## STAFF REPORT

TO: Commissioners, Director, and Deputy Directors  
FROM: Ryan Head, AICP CTP, Planning and Programming Manager  
SUBJECT: **Resolution 2358 - Livable Streets Performance Measures – Consideration for Adoption**  
Staff Report for the June 23, 2021 Commission Meeting

**DRAFT** LIVABLE STREETS PERFORMANCE MEASURES

Post-Public Comment Period

Figure 11. Drawing. Traditional midblock crosswalk lighting layout.

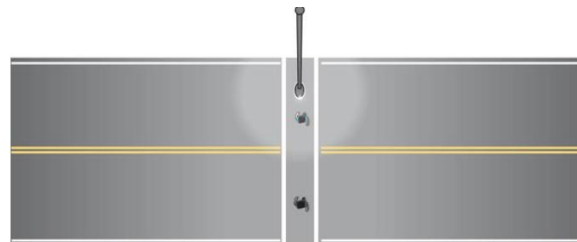
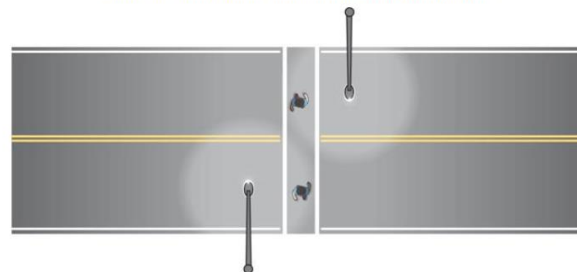
- No Illumination Present – Add 1 LTS
- Adding a Rectangular Rapid Flashing Beacon – Lower 1 LTS
- Pedestrian refuge medians of at least 8' with a vertical element would reduce the total number of lanes crossed at one time to the distance from curb to median.

### Add

- Ramps and pushbuttons inaccessible based on inventory – Add 1 LTS (makes consistent with signalized intersections)
